**RE: Planning Proposal 1-7 Rangers Road and 50 Yeo Street, Neutral Bay
(PP-2022-4350)**

RE: PLANNING PROPOSAL - 1-7 Rangers Road and 50 Yeo Street, Neutral Bay

Attachment B – TfNSW Modelling Comments

RE: PLANNING PROPOSAL - 1-7 Rangers Road and 50 Yeo Street, Neutral Bay – Revised Transport Assessment

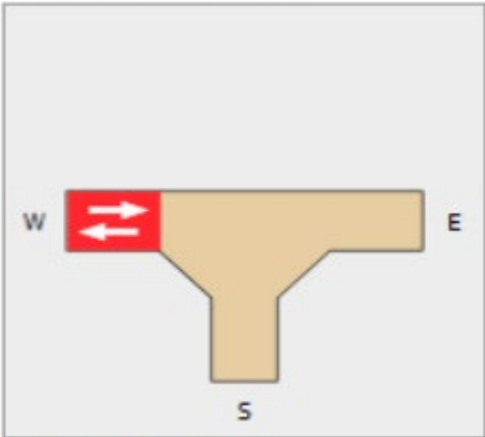
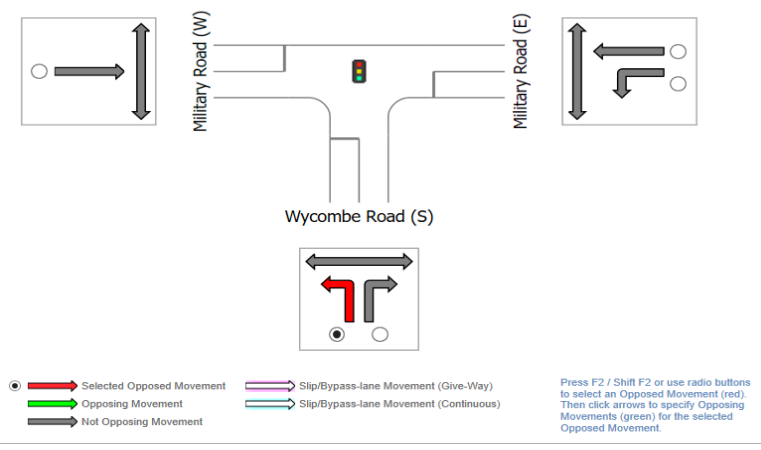
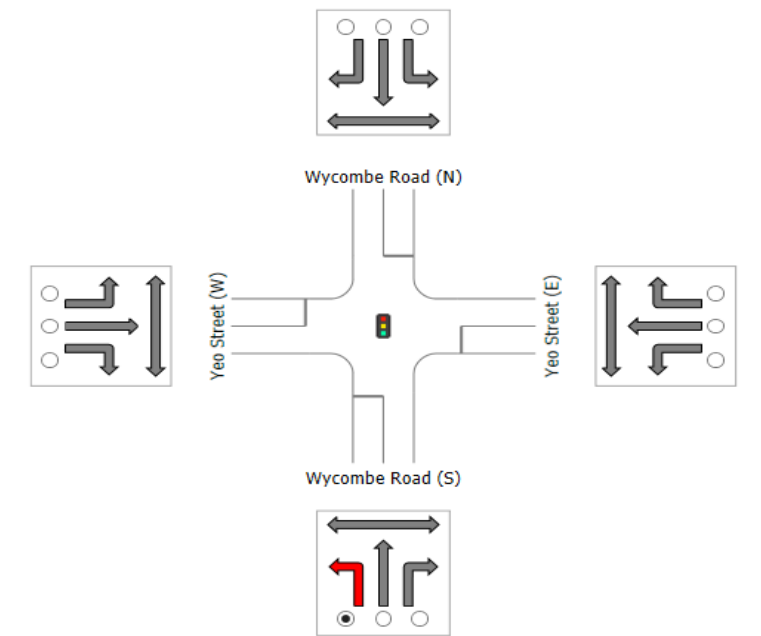
Item	Material	Section	Comment	Priority	Modeller Response	Reviewer Response
1	Model	Lane Geometry	Non default lane data (capacity adjustment ~33% & ~60%) applied for all lanes at Military Road which may reflect site condition. However there is no model calibration and validation provided in the report. Please provide justification or data to support this changes.	Major		
2	Model	Pedestrians	Default 50 Pedestrian per hour were modelled. It does not reflect delays that would occur to traffic being forced to give way to pedestrians especially near high pedestrian activities area (ie across Military Rd)	Medium		
3	Model	Pedestrians Movement Data	The pedestrians uses a default walking speed of 1.3m/s whereas the RMS modelling guidelines recommend 1.2m/s.	Minor		
4	Model	Volume	Percentage of Heavy vehicles volume were used. It is recommended actual survey count to be used or justification and data to be provided.	Medium

5	Model	Priorities	No late start (pedestrian protection) or priority were modelled in all models which assumed no start delay to that traffic movement. However, where traffic movements conflict with pedestrians, delays would occur to traffic being forced to give way to pedestrians. This is likely to result in higher modelled traffic capacity at the intersection than can be realised with pedestrian activity.	Medium		
6	Model	Vehicle Movement Data	Incorrect speed limit – default 60km/h were modelled in all intersections. However 50km/h speed limit is at Wycombe Road, Rangers Road and Yeo Street Lambton Rd and Speed Zone speed limit on Military Rd (East of Rangers Rd) should be applied for both peak (Assumed peak hour within school zone period since the modelling peak periods didn't provide in the report)	Medium		
7	Model	Phasing & Timing	Default intergreen time (6 seconds) were used at Military Rd / Wycombe Rd intersection. It need to be reviewed to reflect the SCATS setting at site.	Minor

PHASING & TIMING - Military Road - Wycombe Road (Site F)

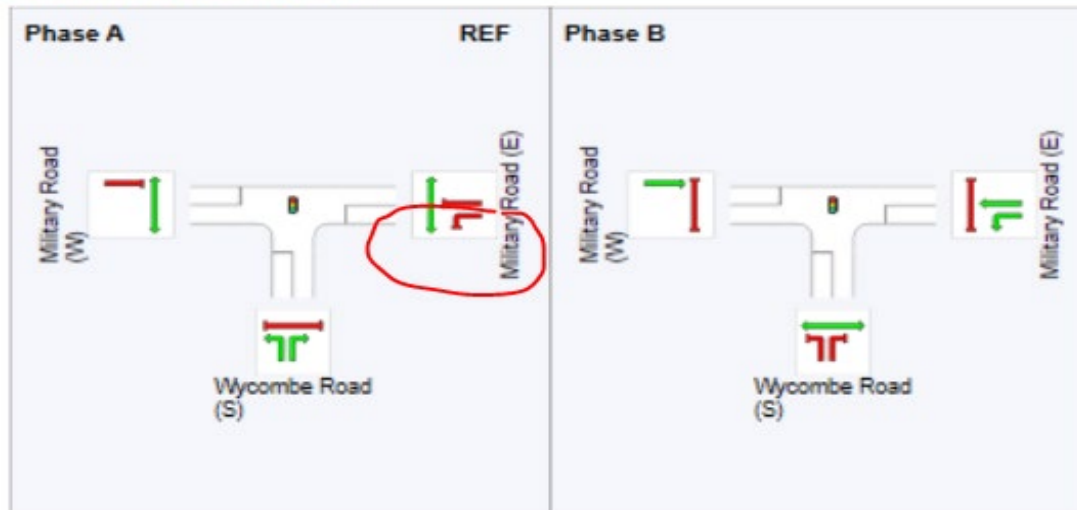
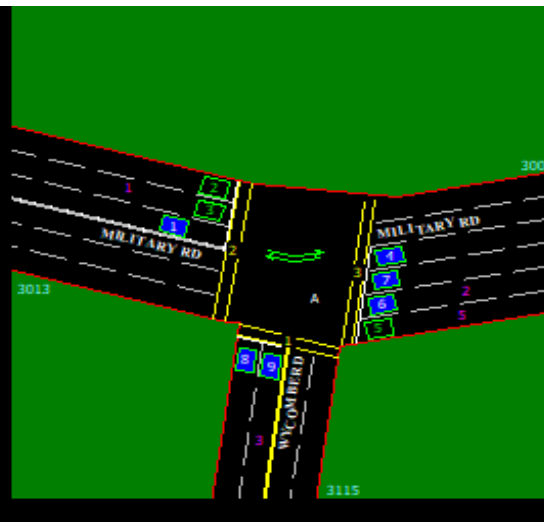
8	Model	Phasing & Timing	According to SCATS phase setting, left turn movement is also running in Phase B (phase A in SIDRA model). Review is needed.	Medium		
9	Model	Phasing & Timing	Late start applied at Military Rd / Wycombe Rd intersection, however they were not included in the model. Review is needed.	Minor		
10	Model	Parameter settings	HV PCU values for all models have been left at the default of 1.65 whereas the RMS modelling guidelines recommend increasing this value to 2.	Minor		
11	Report / Models	Section 4 / Model Scenarios	Not agree to exclude AM peak model in this assessment. Left turn out from Rangers Rd to Military Rd is banned during AM peak, network geometry (2 x AM only bus lanes along Military Rd) and path are significantly different. Also, retails and commercial traffic are operating since AM peak, therefore, AM peak should consider to be assessed the impact to existing road network.	Major
